***Arlington School Committee  
Standing Subcommittee: Facilities  
Wednesday, January 8, 2025  
5:00 PM***

*Discussion of Institute for Human Centered Design Report (2019)*

### PART A – Executive Summary Self- Evaluation and Transition Plan

Town of Arlington  
Bishop Elementary School

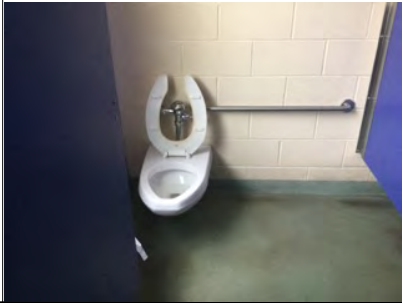
ID	Location	Floor	Room	Element	Type	Photo	Issues	Current Measure	Recommendations	Quantity	Price	Cost Estimation
Additional Access												
50	Classroom 211	2	211	Sink	Classroom		Toe and knee clearances not provided	-	Remove trash bins so that there is a 25" knee clearance positioned for a forward approach.	1	Labor	\$0
Access to Goods and Services												
51	3rd Grade Classroom	2	212	Signage	Designation		Not provided		Locate designation signage with raised characters and braille alongside the door on the latch side.	1	116	\$116
52	3rd Grade Classroom	2	212	Interior Access Route	N/A		Surface not stable, firm, and slip-resistant	-	Secure the mat.	1	Labor	\$0
Access to Goods and Services												
53	3rd Grade Classroom	2	213b	Interior Access Route	N/A		Route < 36" wide	-	Ensure that a clear width of 36" min. is maintained at the accessible route. Relocate furniture.	1	Labor	\$0
54	3rd Grade Classroom	2	213b	Operable Parts	Cubbies		Element not on an accessible route Clear floor space is not provided	- -	Reconfigure desks to ensure student cubbies are located on an accessible route.  Provide a 30" min. by 48" min. clear floor space at the cubbie counter.	1	Labor	\$0

Town of Arlington  
Bishop Elementary School

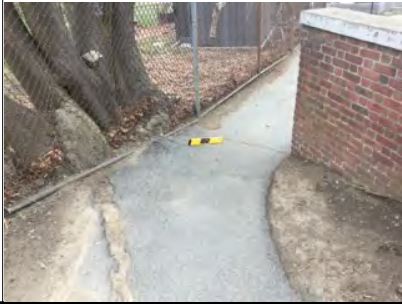
ID	Location	Floor	Room	Element	Type	Photo	Issues	Current Measure	Recommendations	Quantity	Price	Cost Estimation
Access to Goods and Services												
68	Computer/ Art Room	2	227	Operable Parts	Whiteboard		Clear floor space is not provided	-	Reconfigure desks so that there is 36" min. clear width at the white board.	1	Labor	\$0
Additional Access												
69	Computer/ Art Room	2	227	Sink	Classroom		Toe and knee clearances not provided	-	Remove cabinet and provide bracing to ensure that there is a 25" knee clearance positioned for a forward approach.	1	843	\$843
Best Practice												
70	Computer/ Art Room	2	227		Signage				Best Practice: This sign does not reflect the program observed by IHCD staff at the time of review. If this room is to permanently change programs, update signage to reflect the current designation.	1	-	\$0
Best Practice												
71	Science/ Music Room	2	228		Signage				Best Practice: The sign for this room does not reflect the program observed by IHCD staff at the time of review. If this room is to permanently change programs, update signage to reflect the current designation.	1	-	\$0

Town of Arlington  
Brackett Elementary School

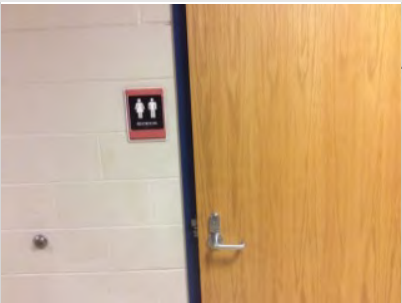
ID	Location	Floor	Room	Element	Type	Photo	Issues	Current Measure	Recommendations	Quantity	Price	Cost Estimation
Access to Goods and Services												
13	Sammarco Gymnasium	1	105	Signage	Designation		Sign not located on the latch side of the door	-	Locate sign at permanent rooms alongside the door on the latch side. Where a tactile sign is provided at double doors with two active leafs, the sign shall be located to the right of the right hand door.	1	Labor	\$0
Access to Goods and Services												
14	General Office	1	106	Signage	Designation		Sign not located on the latch side of the door	-	Locate sign at permanent rooms alongside the door on the latch side.	1	Labor	\$0
Access to Goods and Services												
15	Conference Room	1	106B	Operable Parts	Other		Clear floor space is not provided	-	Reconfigure room layout to provide a 30" min. by 48" min. clear floor space at the white board.	1	Labor	\$0

Town of Arlington  
Brackett Elementary School

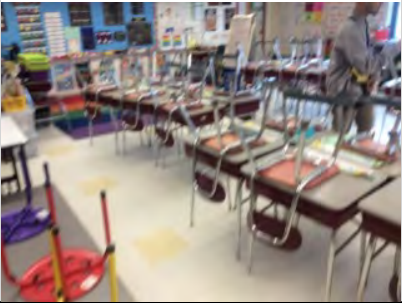
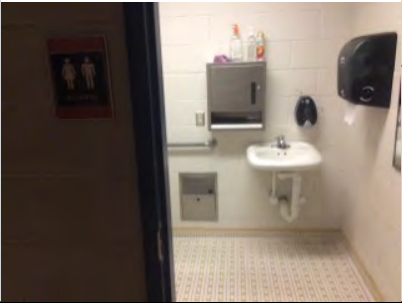
ID	Location	Floor	Room	Element	Type	Photo	Issues	Current Measure	Recommendations	Quantity	Price	Cost Estimation
Access to Goods and Services												
49	Library Office	2	202D	Signage	Designation		Sign not located on the latch side of the door	-	Locate sign at permanent rooms alongside the door on the latch side.	1	Labor	\$0
50	Library Office	2	202D	Operable Parts	Other		Clear floor space is not provided	-	Provide a 30" min. by 48" min. clear floor space at the white board.	1	Labor	\$0
Access to Goods and Services												
51	Science Room	2	204	Interior Access Route	N/A		Surface not stable, firm, and slip-resistant	-	Relocate the cables.	1	Labor	\$0
Additional Access												
52	Science Room	2	204	Sinks for Children's Use	Classroom		Knee or toe clearance not provided	-	Provide at least one sink with 25" knee and toe clearance positioned for a forward approach.	1	843	\$843

Town of Arlington  
Dallin Elementary School

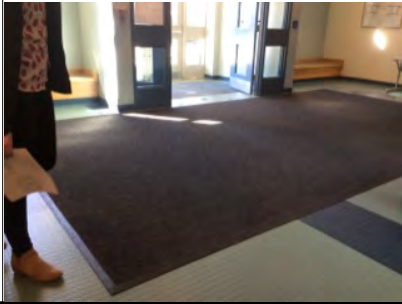
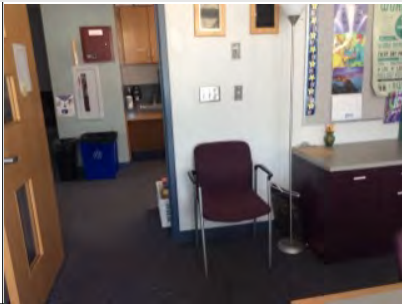
ID	Location	Floor	Room	Element	Type	Photo	Issues	Current Measure	Recommendations	Quantity	Price	Cost Estimation
Access to Goods and Services												
1	Elevator			Elevator	Interior		Hoistway signs not on both jambs	-	Provide hoistway signs on both sides of jambs. At the main entry level, ensure the hoistway signs have a tactile star.	4	48	\$192
Access to Goods and Services												
2	Administration Office	1		Operable Parts	Equipment		Reach < 15" or > 48"(forward/side approach)	63"	Relocate AED device so that controls are between 15"- 48" above finished floor.	1	128	\$128
Approach and Entrance												
3	Exit 10	1		Emergency Exit	N/A		Automatic door opener not operable	-	Repair or replace the door opener.	1	1350	\$1350
Access to Goods and Services												
4	Exit 10	1		Means of Egress	N/A		Illuminated exit sign not provided Tactile exit sign not provided	- -	Provide illuminated exit signs with the International Symbol of Accessibility at accessible exits. Provide tactile exit signs with raised characters and braille at exit doors. Mount signs between 48"- 60" above finished floor located on the latch side of the door.	2	116	\$232

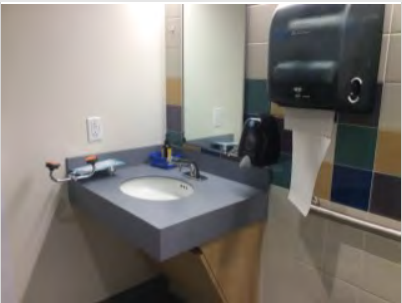
ID	Location	Floor	Room	Element	Type	Photo	Issues	Current Measure	Recommendations	Quantity	Price	Cost Estimation
Additional Access												
9	Near Main Office	1		Drinking Fountains	Low		No drinking fountain provided for standing users	-	Provide an additional drinking fountain for standing users.	1	2014	\$2014
Access to Goods and Services												
10	Nurse's Office	1		Doors, Doorways, & Gates	Other		Maneuvering clearance(s) not provided	-	Remove the table to provide 18" clear on the latch pull side of the door.	1	Labor	\$0
Access to Goods and Services												
11	Stair 1	1		Interior Access Route	N/A		Obstructed by protruding objects	45"	Provide a cane-detectable barrier at the valve.	1	153	\$153
Access to Goods and Services												
12	Stair 1, Near Cafeteria	1		Doors, Doorways, & Gates	Circulation		Maneuvering clearance(s) not provided	-	Remove the arrow sign to provide 18" clear on the latch pull side of the door.	1	Labor	\$0

Town of Arlington  
Gibbs School

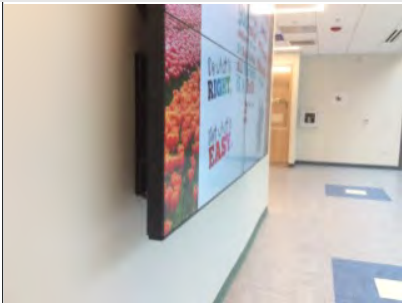
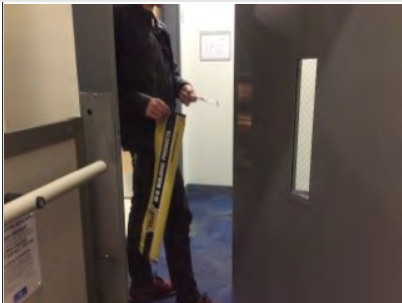
ID	Location	Floor	Room	Element	Type	Photo	Issues	Current Measure	Recommendations	Quantity	Price	Cost Estimation
Access to Goods and Services												
21	Toilet Room in Nurse's Office	1	126	Doors, Doorways, & Gates	Toilet Room		Maneuvering clearance(s) not provided	-	Relocate the shelving unit to provide 18" clear on the latch pull side of the door.	1	Labor	\$0
Toilet & Bathing Rooms												
22	Toilet Room in Nurse's Office	1	126	Dispensers	Paper Towel Dispenser		Dispenser controls > 42" high	51"	Relocate so the paper towel dispenser so the operable part is 42" max. above the finished floor. Ensure the paper towel dispenser is not mounted over the grab bar or in the circulation path.	1	353	\$353
Toilet & Bathing Rooms												
23	Toilet Room in Nurse's Office and Girls' Toilet Room 135	1	126 135	Dispensers	Hand Dryer		Dispenser acts as a protruding object	35"	Relocate the hand dryer out of the circulation path.	2	353	\$706

**Town of Arlington  
Hardy Elementary School**

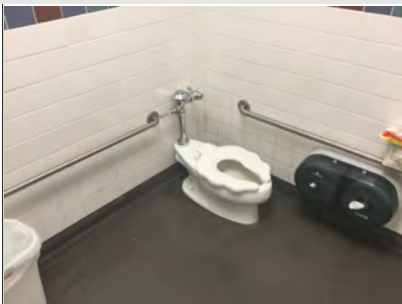
ID	Location	Floor	Room	Element	Type	Photo	Issues	Current Measure	Recommendations	Quantity	Price	Cost Estimation
Access to Goods and Services												
5	Reading Room, Speech and Language Room	1	104A 103A	Interior Access Route	N/A		Surface not stable, firm, and slip-resistant	-	Securely attach all the mats in the room.	3	Labor	\$0
Access to Goods and Services												
6	Reading Room, Kindergarten Classroom	1	104A 121	Dining or Work Surfaces	Work Surface		At least one or 5% accessible tables not provided	22.5"	Ensure that at least one work surface is accessible with 24" high of knee and toe clearance min.	2	350	\$700
Access to Goods and Services												
7	Library/ Instructional Materials Center	1	105A	Signage	Designation		Braille not provided	- -	Ensure that braille is not obscured by paper sign.  Best Practice: Consider simplifying language to say "Library."	1	Labor	\$0
Access to Goods and Services

**Town of Arlington  
Hardy Elementary School**

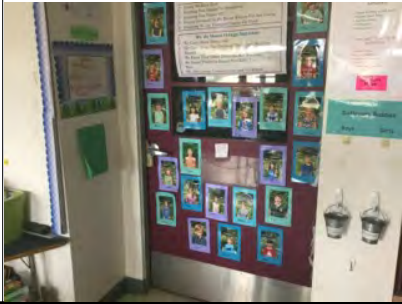
ID	Location	Floor	Room	Element	Type	Photo	Issues	Current Measure	Recommendations	Quantity	Price	Cost Estimation
<b>Additional Access</b>												
61	Classroom 12	2	209 / 212	Sink	Classroom		Toe and knee clearances not provided	18" deep	Ensure there is knee clearance positioned for a forward approach by relocating the recycling bin. 18" deep at the sink is not entirely compliant, but usable.	1	Labor	\$0
<b>Toilet Rooms for Children</b>												
62	Boys' Toilet Room	2	210 / 218	Toilet Compartment	Accessible Compartment		Door with malfunctioning self-closing hinge Non-compliant toilet paper dispenser	- -	Repair self-closing hinge. Replace toilet paper dispenser as it does not allow continuous paper flow.	1	Labor 353	\$353
63	Boys' Toilet Room	2	210 / 218	Dispensers	Paper Towel Dispenser		Dispenser not operable with a closed fist	-	Provide a paper towel dispenser that can be operable with one hand and not require tight grasping, pinching, or twisting of the wrist.	1	453	\$453

Town of Arlington  
Ottoson Middle School

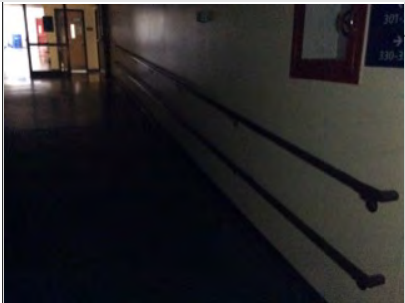
ID	Location	Floor	Room	Element	Type	Photo	Issues	Current Measure	Recommendations	Quantity	Price	Cost Estimation
Best Practice												
77	Classroom Near 334	3	-						Best Practice: Recommend providing signage at all classrooms to improve access and create consistent wayfinding.	1	-	\$0
Best Practice												
78	Elevator	3							Best Practice: Recommend redesigning button designation signage to have more intuitive floor designations. Current design does not reflect the generally recognized floor order; LL is floor 2, 1 is floor 3, 2 is floor 4, etc.	1	-	\$0
Access to Goods and Services												
79	Elevator Near 321	3		Elevator	Interior		Elevator doors remain fully open < 3 seconds	- -	Adjust closer on elevator door so that doors remain open for at least 3 seconds.	1	Labor	\$0
Toilet & Bathing Rooms												
80	Girl's Toilet Room Near 321	3		Lavatory	N/A		Plumbing underneath is exposed	-	Insulate or otherwise configure pipes to prevent contact at lavatory.	1	46	\$46

Town of Arlington  
Ottoson Middle School

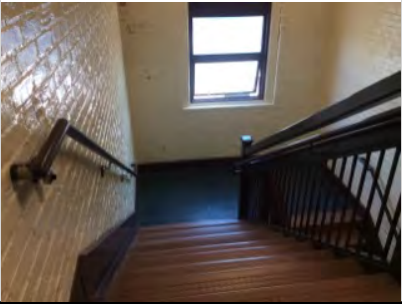
ID	Location	Floor	Room	Element	Type	Photo	Issues	Current Measure	Recommendations	Quantity	Price	Cost Estimation
Access to Goods and Services												
102	Classroom	3	335	Doors, Doorways, & Gates	Classroom		Maneuvering clearance not provided at recess > 8"	-	Relocate the storage out out of the door maneuvering clearance.	1	Labor	\$0
Access to Goods and Services												
103	Special Education Classroom	3	338	Interior Access Route	N/A		Route < 36" wide	28"	Relocate furniture to provide a clear width of 36" min.	1	Labor	\$0
Access to Goods and Services												
104	Classroom	3	355	Interior Access Route	N/A		Surface not stable, firm, and slip-resistant	-	Secure the mat.	1	Labor	\$0
Access to Goods and Services												
105	Boy's Toilet Room Near 447	4		Doors, Doorways, & Gates	Toilet Room		Maneuvering clearance(s) not provided	-	Remove or relocate the trash bin away from the door maneuvering clearance.	1	353	\$353

**Town of Arlington**  
**Peirce Elementary School**

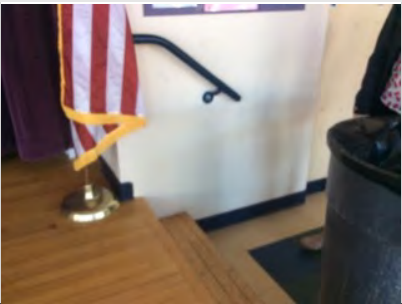
ID	Location	Floor	Room	Element	Type	Photo	Issues	Current Measure	Recommendations	Quantity	Price	Cost Estimation
53	Parking Lot Along Newland Road	Ext.		Off-Street Parking Lot or Garage	N/A		Access aisle does not adjoin an accessible route	-	Ensure the access aisle adjoins an accessible route.  (Cost based on restriping space so that access aisle is on the right side and adjoins with curb cut.)	1	150	\$150
<b>Play and Sport Areas</b>												
54	Playground with Climbing Structure North of Basketball Court	Ext.		Play Areas	N/A		Accessible route not provided to play components Accessible route not provided around the playground	22' 30'	Provide an accessible impact-attenuating surface that is 60" wide to play components. Provide an accessible route that is 48" wide along each side of the playground. Due to the size of the play ground, it may be technically infeasible to provide a route along the fence side. (Cost estimate based on 22' of poured in place to the play components and 30' of asphalt routes alongside the play area.)	1	2580	\$2580

Town of Arlington  
Spy Pond Field House

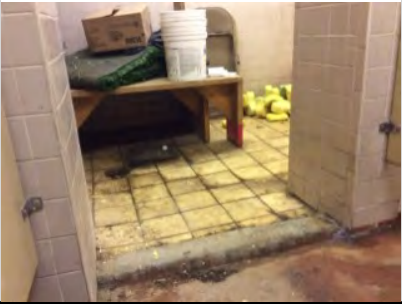
ID	Location	Floor	Room	Element	Type	Photo	Issues	Current Measure	Recommendations	Quantity	Price	Cost Estimation
Access to Goods and Services												
1	Accessible Toilet Room	1		Doors, Doorways, & Gates	Toilet Room		Hardware not operable with a closed fist		Provide hardware that can be operable with one hand and not require tight grasping, pinching, or twisting of the wrist.	1	242	\$242
2	Accessible Toilet Room	1		Signage	Designation		. Sign not located on the latch side of the door		Locate sign at permanent rooms alongside the door on the latch side.	1	Labor	\$0
Toilet & Bathing Rooms												
3	Accessible Toilet Room	1		Single-User Toilet	N/A		Centerline < or > 18" (MAAB) Rear grab bar > 42" long	29" -	Relocate toilet so that the centerline is 18" from the side wall. Provide a rear wall grab bar that is 42" long min. and extends from the toilet 12" min. on one side and 24" min. on the other side (open side).	1	1863	\$1863

Town of Arlington  
Community Safety Building

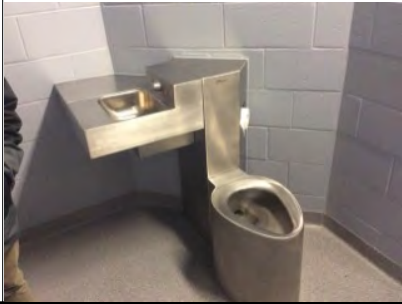
ID	Location	Floor	Room	Element	Type	Photo	Issues	Current Measure	Recommendations	Quantity	Price	Cost Estimation
Access to Goods and Services												
1	Stairs To Level 2	1	-	Stairways	Interior		Handrails do not extend 12" from stairs	-	Bottom: Ensure handrails extend to one tread depth beyond the last riser.	2	71	\$142
Access to Goods and Services												
2	Administration Counter	2	-	Service Counter	N/A		Counter > 36" high	44"	Provide a counter that is 36" max. above the ground or finish floor.	1	440	\$440
Access to Goods and Services												
3	Community Room	2	-	Doors, Doorways, & Gates	Assembly Space		Automatic door opener not operable	-	Repair or replace the door opener.	1	Labor	\$0
Universal Design												
4	Community Room	2	-					-	Best Practice: Consider providing an adjustable height podium with room for knee and toe clearance.	1		\$0

Town of Arlington  
Highland Fire Station

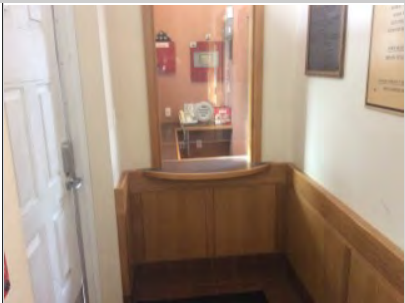
ID	Location	Floor	Room	Element	Type	Photo	Issues	Current Measure	Recommendations	Quantity	Price	Cost Estimation
Approach and Entrance												
Off-Street Parking Lot or Garage												
1	Parking Lot	Ext.		Off-Street Parking Lot or Garage	Visitor		Total # of parking Total # of designated accessible parking spaces Total # of designated van accessible spaces	8 0 0	Provide one van accessible spot with a sign designated "Van Accessible". (Cost estimate for sign, striping and leveling of one van-accessible parking space.) In addition, as best practice, consider locating an accessible on-street parking space near the facility with a compliant curb ramp and clear and level space along the sidewalk.	1	925	\$925
Emergency Exit												
2	Call Counter	1		Emergency Exit	N/A		Maneuvering clearance(s) not provided	44"	Provide an automatic door opener.	1	1530	\$1530
Access to Goods and Services
